BURLINGTON DEVELOPMENT REVIEW BOARD

Tuesday June 3, 2014

MEMORANDUM

To: Development Review Board
From: Mary O'Neil, AICP, Senior Planner *MO*
Date: June 3, 2014
RE: ZP 13-0650CA/MA 110 Riverside Avenue

PLANTING PLAN

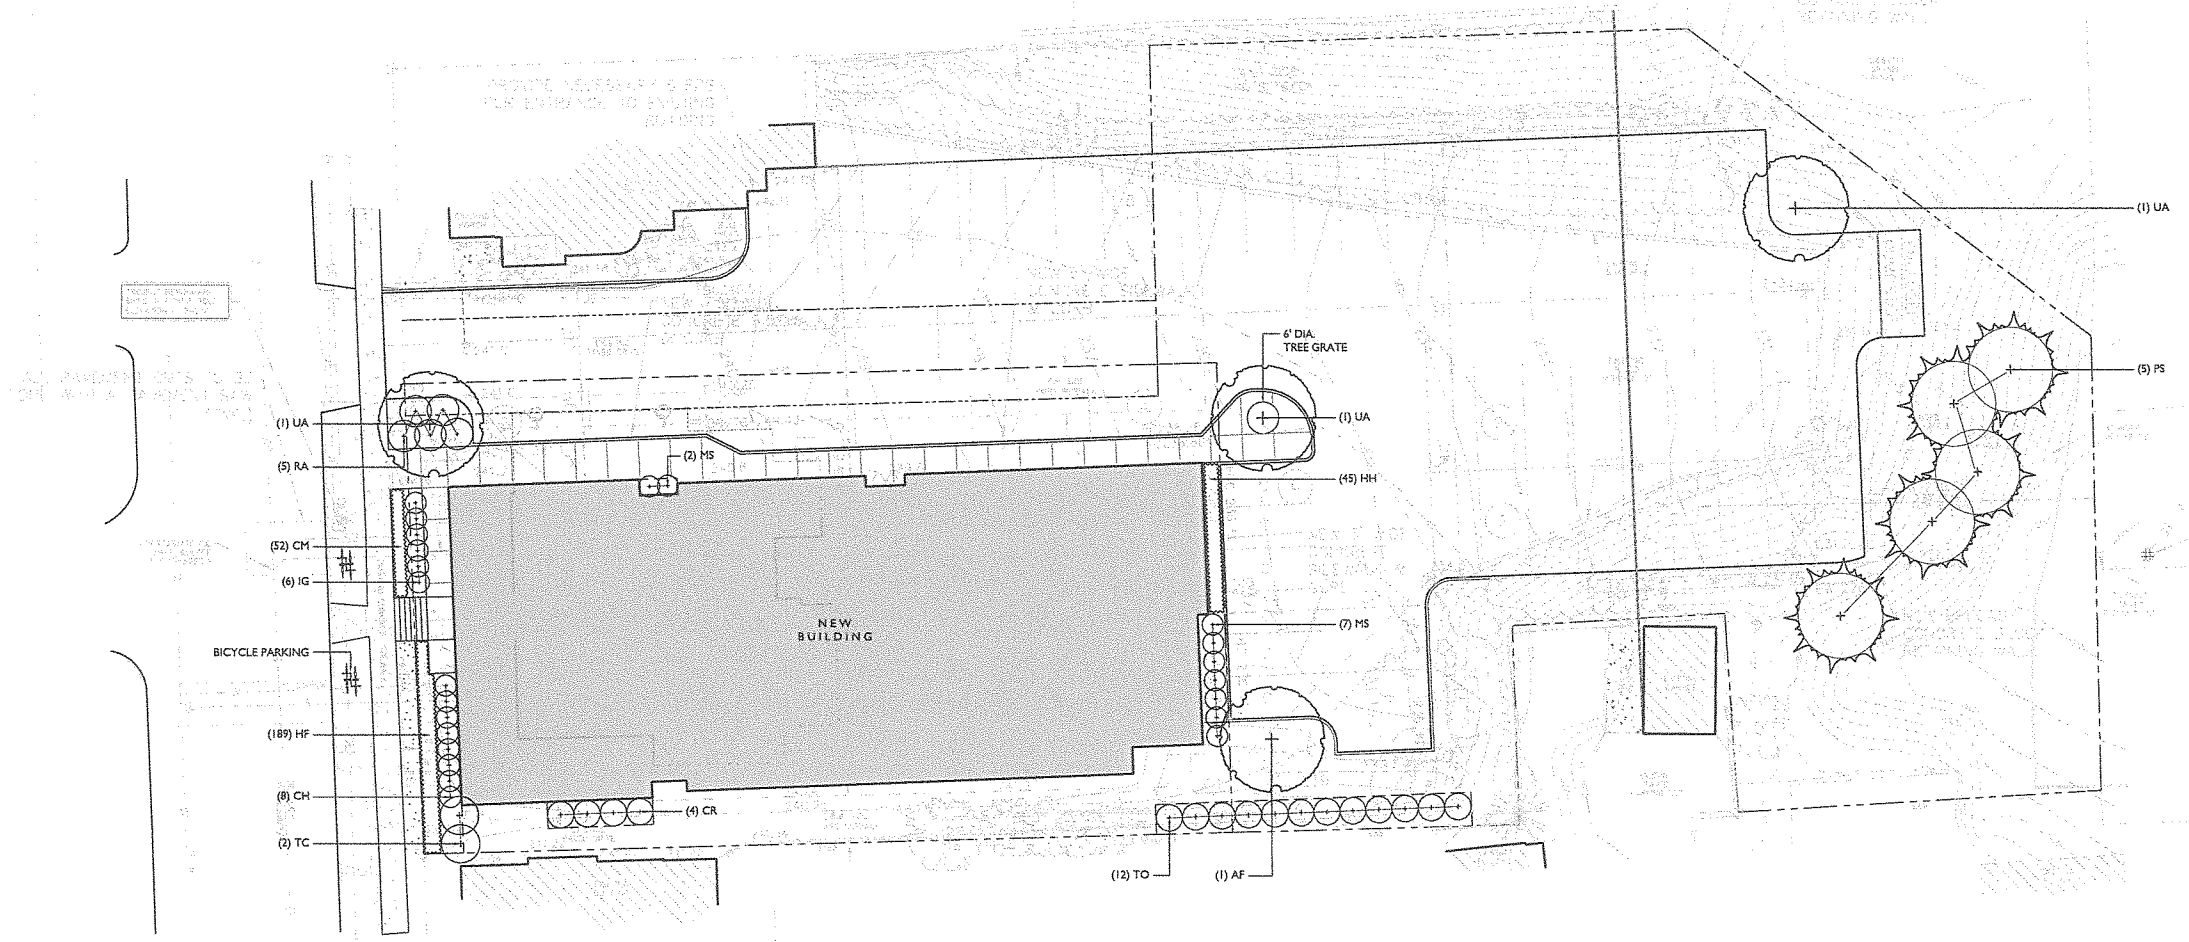
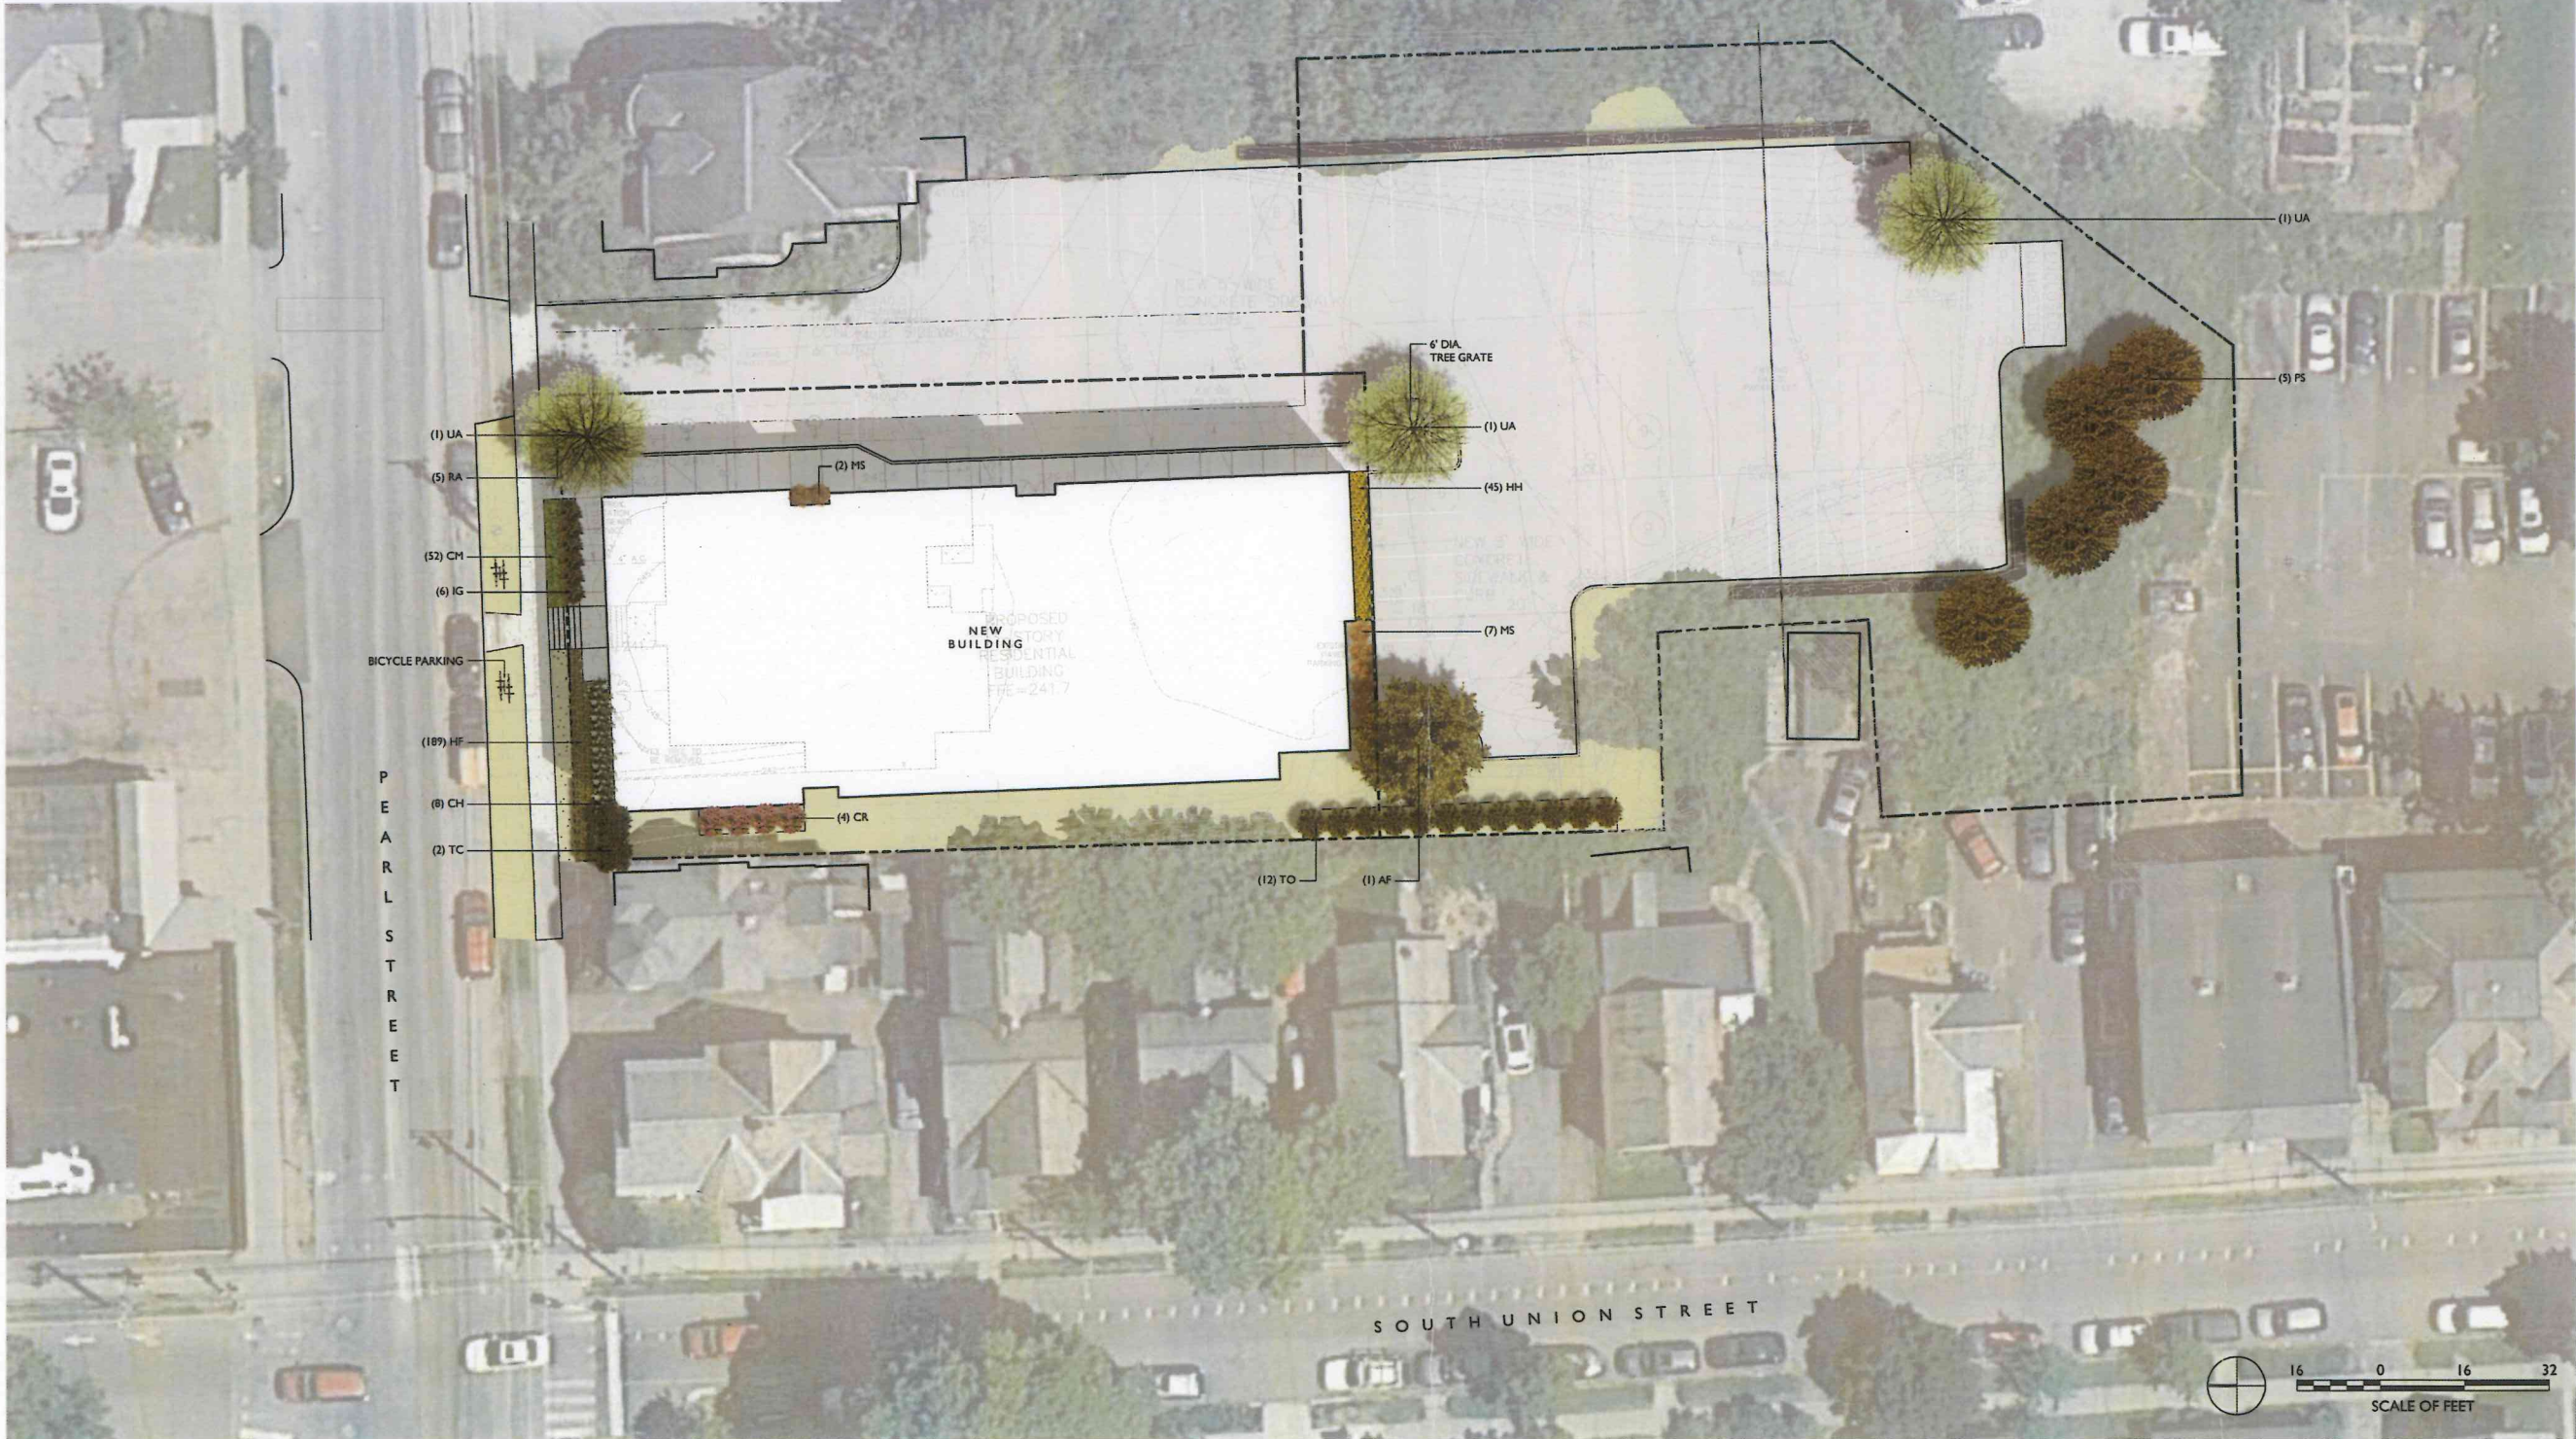
A Planting plan has been submitted (L1.0) that defines new landscaping along portions of the westerly property line, as well as 5 White Pine and an elm tree along the southerly portion of the lot. Two specimen trees are articulated along the walkway (Princeton American Elm) although it is supposed that these are not intended to provide screening but beauty. They will likely be used to meet the requirement for parking lot shading. See Sec. _____, below.

The plan will be required to provide 8 trees meeting the above specified minimum caliper to meet the shading standard ($41 / 5 = 8.2$.) A landscaping plan has been submitted, with 8-9 new trees proposed.

**ELEVATION  
DUMPSTER ENCLOSURE**  
N.T.S.

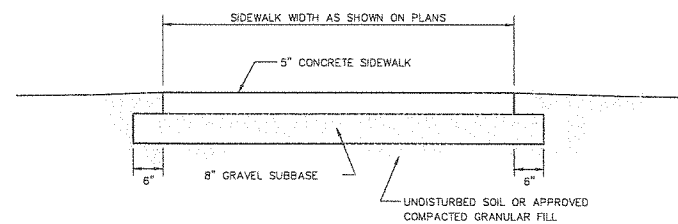
Utilities must be undergrounded. The method and design of the dumpster enclosure has been included (Plan C2.2.) While the material has not been identified, vinyl is not recommended due to the likelihood of failure.
